UNITED STATES PATENT AND TRADEMARK OFFICE

Office Action Summary

10/604,582

DETAILED ACTION

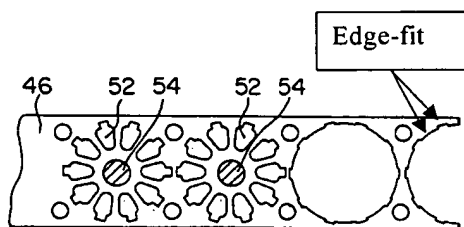
- providing a hollow cylindrical jig (Fig. 2B, 74) having at least one guide or edge-fit (Fig.

2A, see below) to fit the lamination;

- providing plates or laminations (Fig. 3B, 42), each having a central opening, radial poles with caps at the end of each pole, and having a guide or edge-fit (Fig. 2A, see below) corresponding in shape to mate with the at least one guide in the jig;
- providing a stop (Fig. 2B, below 42) in a jig;
- sliding each plate (Fig. 2B, 42) in the jig with the guide in the plate mating with the guide in the jig, and with the first plate bearing against the stop until a plurality of plates are disposed in the jig;
- pressing a shaft into the central openings (Fig. 3C, 44).

As applied to claim 13, Kanno teaches that the guide or edge-fit (Fig. 2A, see above) in the jig (Fig. 2B, 74) is an axial rib and the guide in each plate is a notch.
